In re Applications of)	MM Docket No. 93-89
)	
AURIO A. MATOS)	File No. BPH-911114MS
)	
LLOYD SANTIAGO-SANTOS and LOURDES)	File No. BPH-911115MP
RODRIGUES-BONET)	
)	
For Construction Permit for a New)	
FM Station on Channel 293A in)	
Culebra, Puerto Rico)

To: The Review BoardFEDERAL COMMUNICATIONS COMMISSION
OFFICE OF SECRETARYPETITION FOR LEAVE TO AMEND

AMENDMENT OF BPH-911114MS
AURIO MATOS BARRETO
CHANNEL 239 - CLASS A
CULEBRA, PUERTO RICO
MAY 1994

AMENDMENT OF BPH-911114MS
AURIO MATOS BARRETO
CHANNEL 239 - CLASS A
6 KW - 166 M HAAT
CULEBRA, PUERTO RICO
May 1994

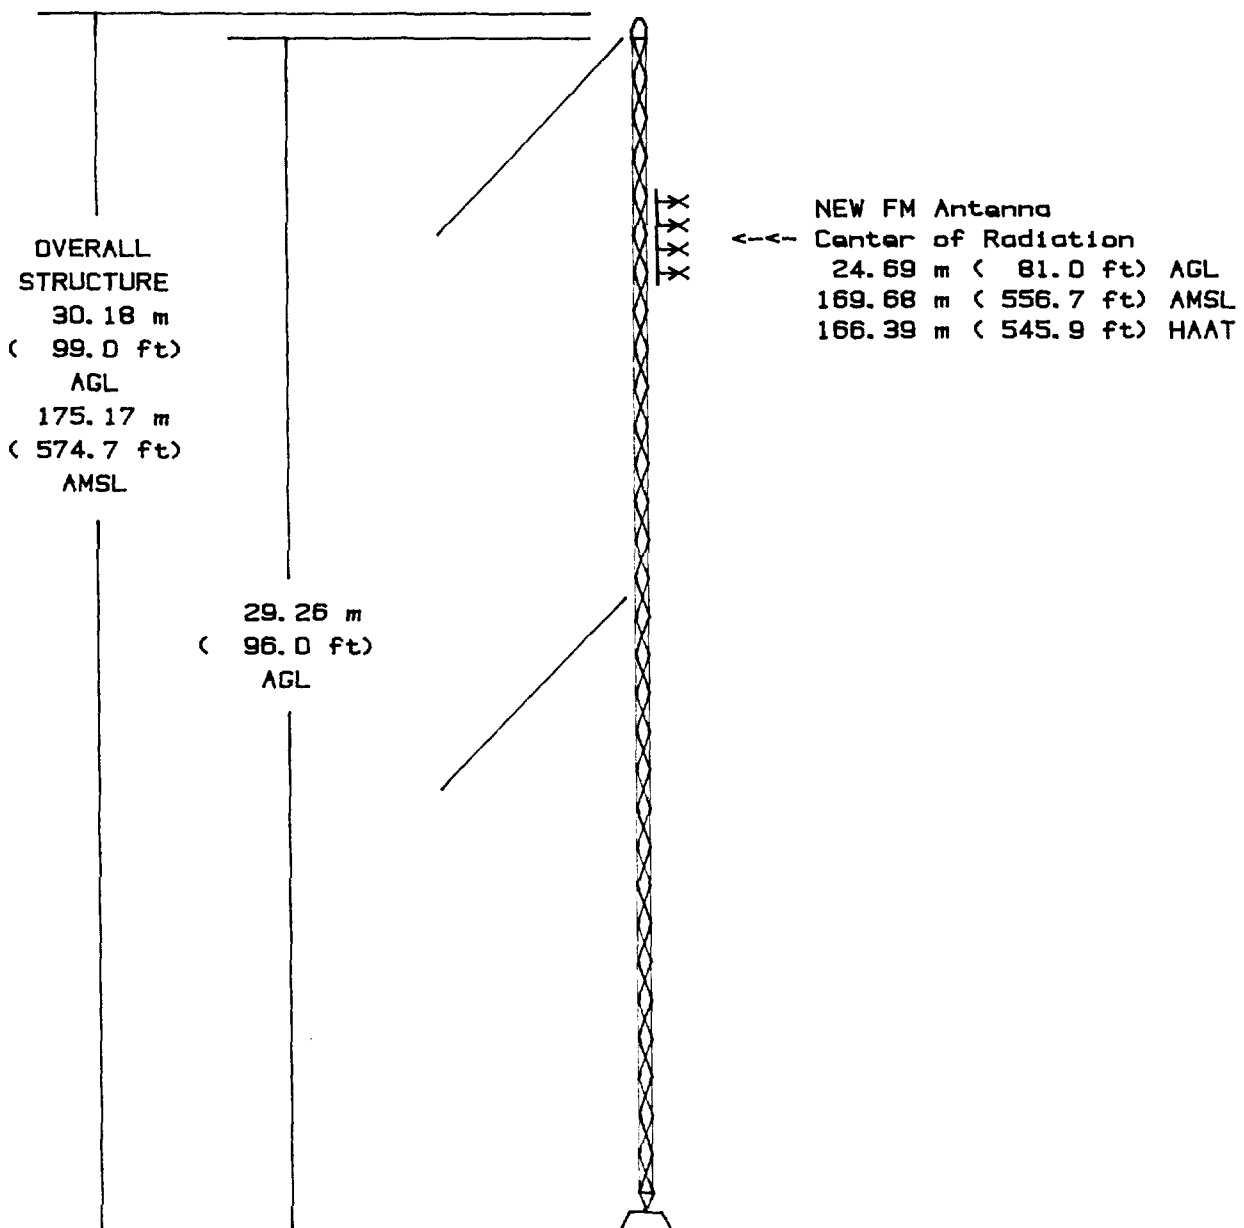
The proposed antenna tower would be located approximately 0.55 nautical miles (NM) northwest of the Culebra Airport reference point, in Culebra, PR. It would exceed obstruction standards contained in Part 77, Subpart C, of the Federal Aviation Regulations as follows:

77.23(a)(5) by the entire proposed height, a height that exceeds an imaginary horizontal and transitional surface as applied to the Culebra Airport.

Study for visual flight rules (VFR) effect disclosed that the proposal would not penetrate any known public use or military airport traffic pattern airspace areas. The proposal at 99 feet AGL would not penetrate altitudes considered available for VFR en route operations.

Therefore, it is determined that the proposed structure would have no substantial adverse effect on the safe and efficient utilization of the navigable airspace by aircraft or on the operation of air navigation facilities and would not be a hazard to air navigation.

VERTICAL PLAN SKETCH

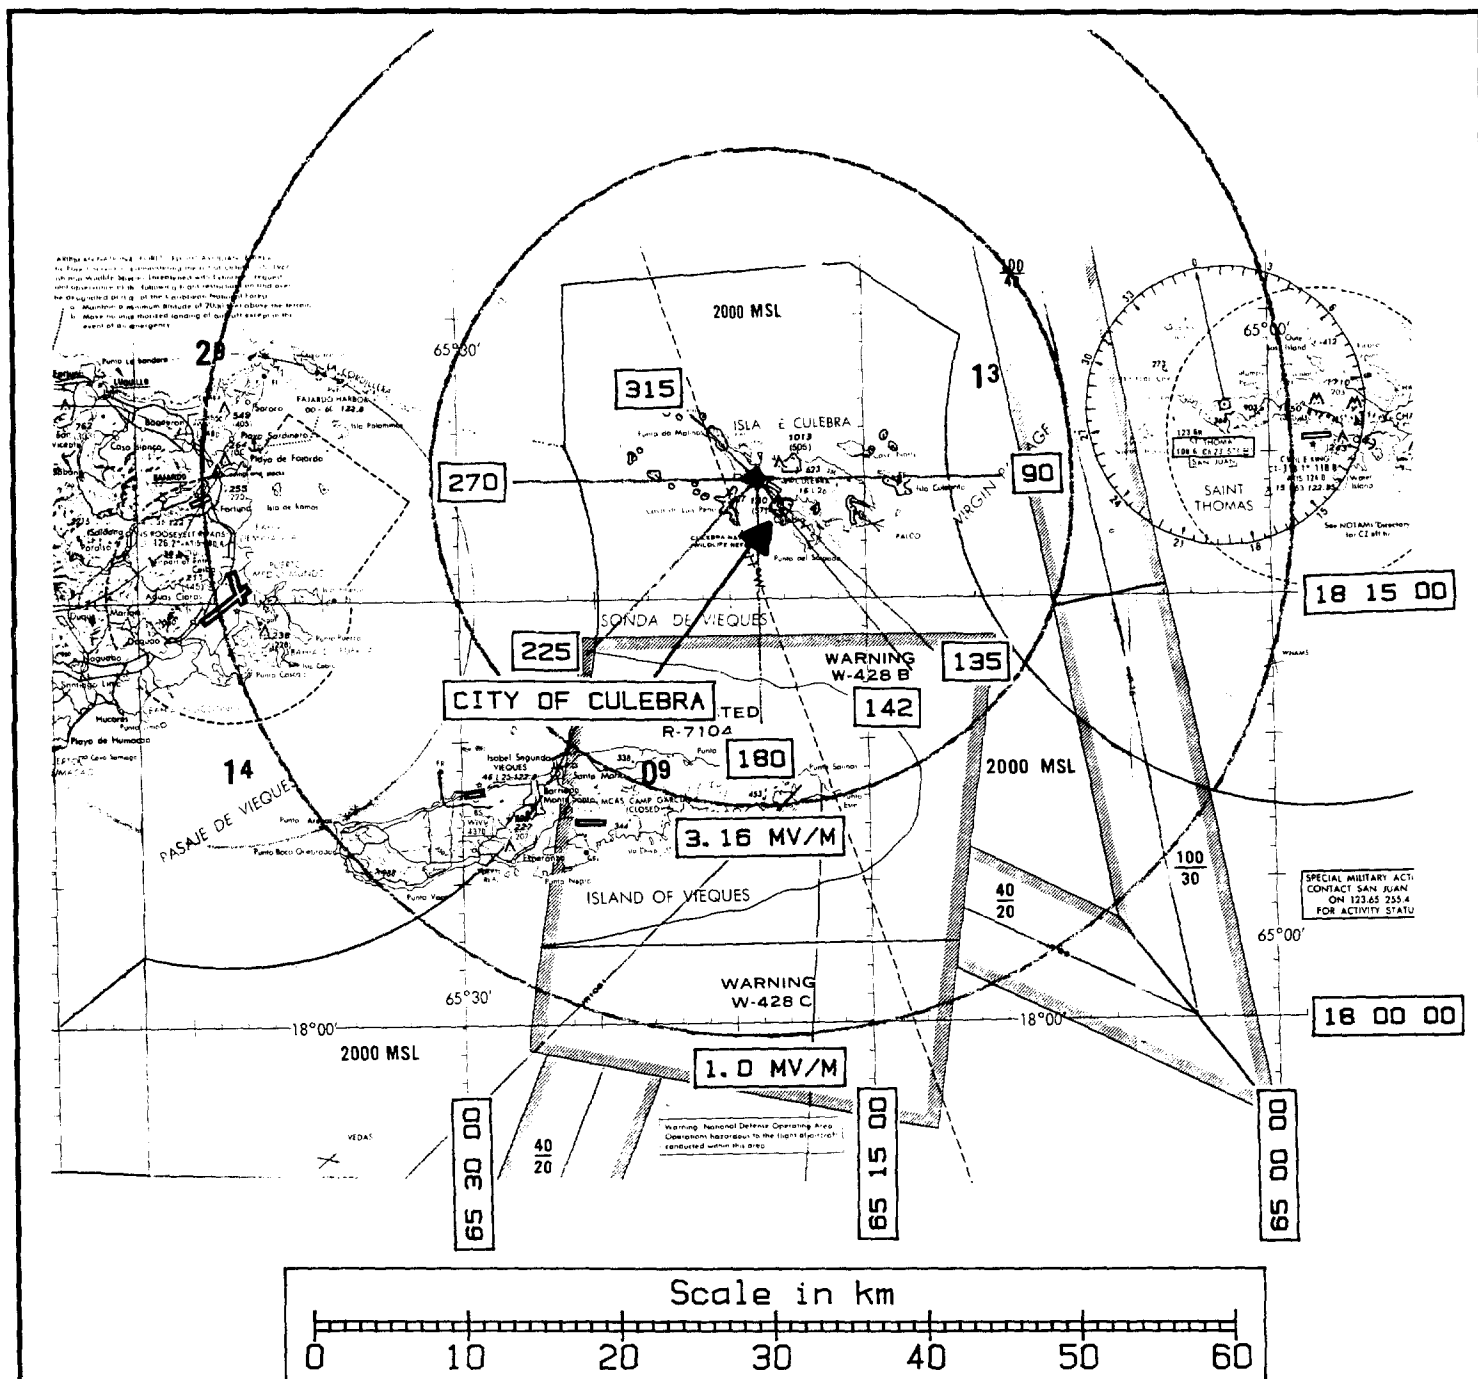
TOP OF STRUCTURE - 30 m (99 ft) AGL
175 m (575 ft) AMSL

FM Antenna COR - 25 m (81 ft) AGL
170 m (557 ft) AMSL
166 m (546 ft) HAAT
